Errata Sheet

FirstNet Nationwide Public Safety Broadband Network

Final Programmatic Environmental Impact Statement for the Non-Contiguous United States Region

May 2017

Figure 1: FirstNet's Notional Deployment Approach

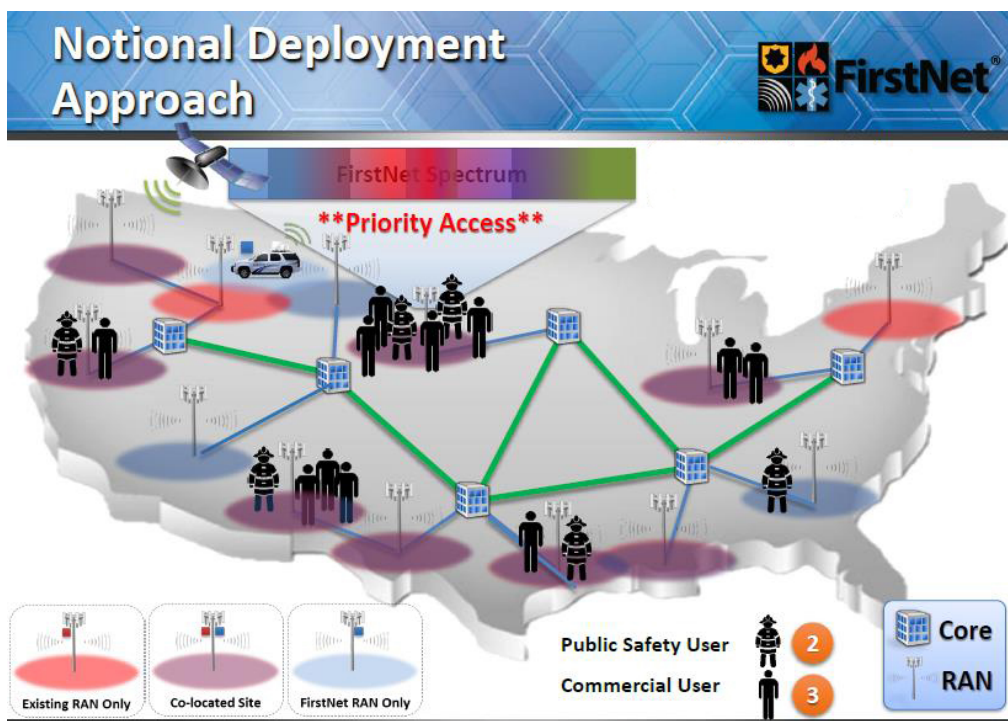
In describing the proposed infrastructure, I would recommend including diagrams, if possible, so people can understand how the system will interface across different platforms.	Figure 1 below provides a diagram of FirstNet’s notional deployment approach. Please visit FirstNet’s website ³ for additional informational materials on the system.	Section 2.1

Figure 2: An Estimate of Avian Mortality at Communication Towers in the U.S. and Canada (Provided by the USFWS)

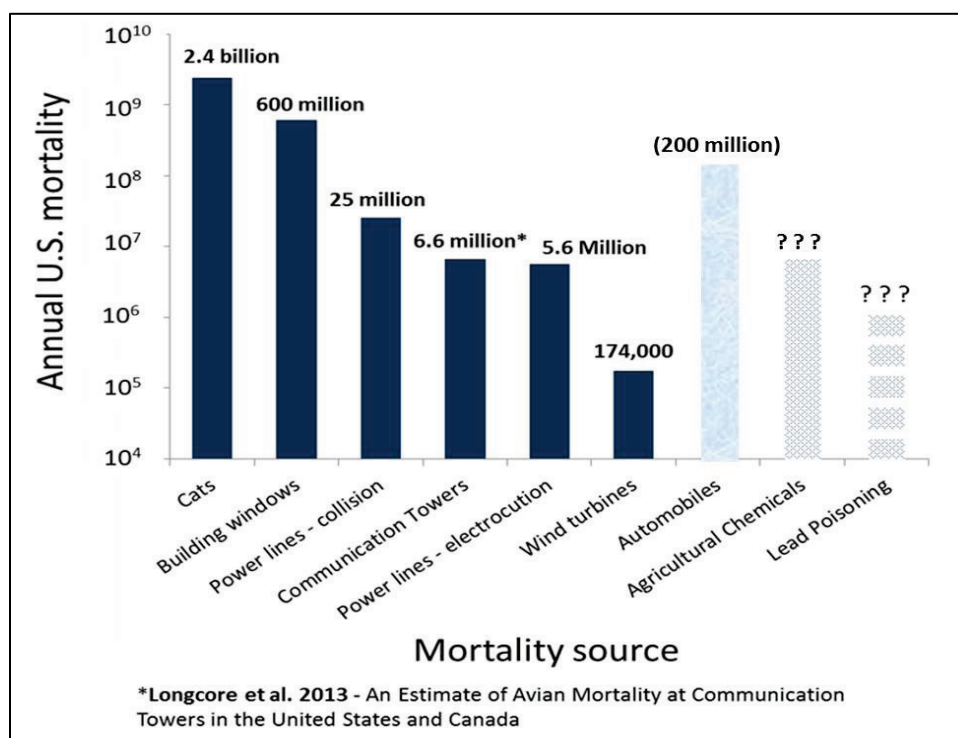
Comment Text	Response	Relevant Section(s) in Final PEIS
<i>Section 3.0: Wildlife and Vegetation</i>		
<p>Regarding migratory birds and direct mortality, reference to causes of mortality should include those listed in the updated communication tower guidance from FWS. See page 1 of that guidance for reasons for mortality, which are a little more specific than those listed in the PEIS.</p>	<p>The USFWS' <i>Recommended Best Practices for Communication Tower Design, Siting, Construction, Operation, Maintenance, and Decommissioning</i> (USFWS 2016) elaborates on the specific causes of bird mortality as follows:</p> <p>“Given the height, structural engineering needs (i.e., guy wires), and obstruction lighting requirements, communication towers may cause direct and indirect bird mortality through:</p> <ol style="list-style-type: none"> 1. Collisions - Birds that are attracted to tower lights and aggregate in the lighting zone, circle the tower and collide with the tower, guy wires, other birds, or fall to the ground from exhaustion (Longcore et al. 2012b, Gauthreaux and Belser 2006, Erickson et al. 2005). 2. Construction, operation, and maintenance activities - Adults, eggs, or nestlings can experience direct mortality through: <ol style="list-style-type: none"> a. Trauma or death during vegetation removal; b. Trauma or death during tower maintenance; and c. Death of eggs or nestlings when actions or activities cause adults to abandon nests. 3. Significant loss of fat reserves in adults due to the energy expenditure of circling towers, leading to reduced survival during long migrations (Norris and Taylor 2006, Gehring and Walker 2012).” <p>In addition, the <i>Recommended Best Practices</i> provide updated avoidance and minimization measures. Those measures replace the USFWS guidelines on communications tower siting in Chapter 11.</p>	<p>All Environmental Consequences Wildlife sections (3.2.6.4; 4.2.6.4; 5.2.6.4; 6.2.6.4; 7.2.6.4; 8.2.6.4; 9.2.6.4) and Chapter 11 (Section 11.6.2)</p>
